# PLANNING DIVISION STAFF REPORT

**Project Address:** 4301 Cherokee Drive (10<sup>th</sup> Alder District – Alder Figueroa Cole)

**Application Type:** Demolition Permit and Conditional Use

**Project Title:** 4301 Cherokee Drive - Public Building for MMSD Cherokee Middle School. (District 10)

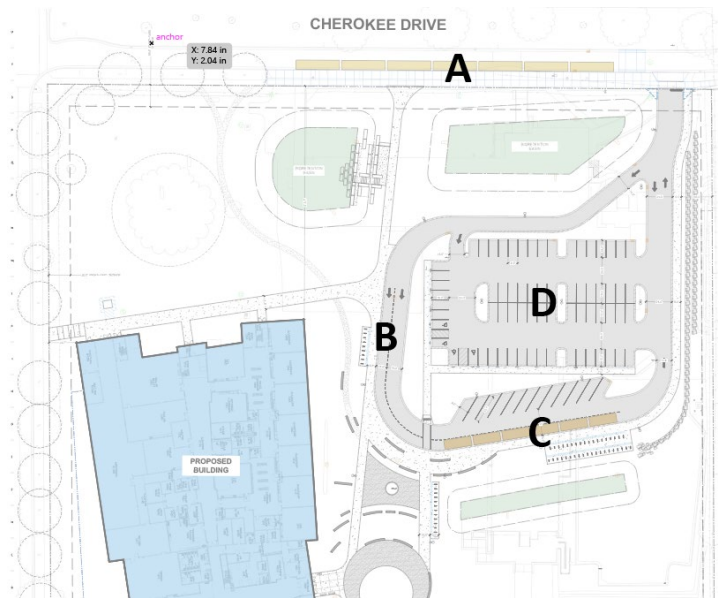
Regarding students and staff getting to and from the school, yellow school buses will stop along the south side of Cherokee Drive (this area is marked “A” in the graphic to the right). In the morning these buses will just drop the students off and then leave while in the afternoon they will typically queue and then load and leave 10 minutes after the bell time of the school. The drop off/pick up area for parents/guardians in personal vehicles is marked “B” in the graphic while “C” indicates the loading zone for Paratransit. Finally, the central parking lot, indicated by “D” in the graphic, is for staff and visitors.
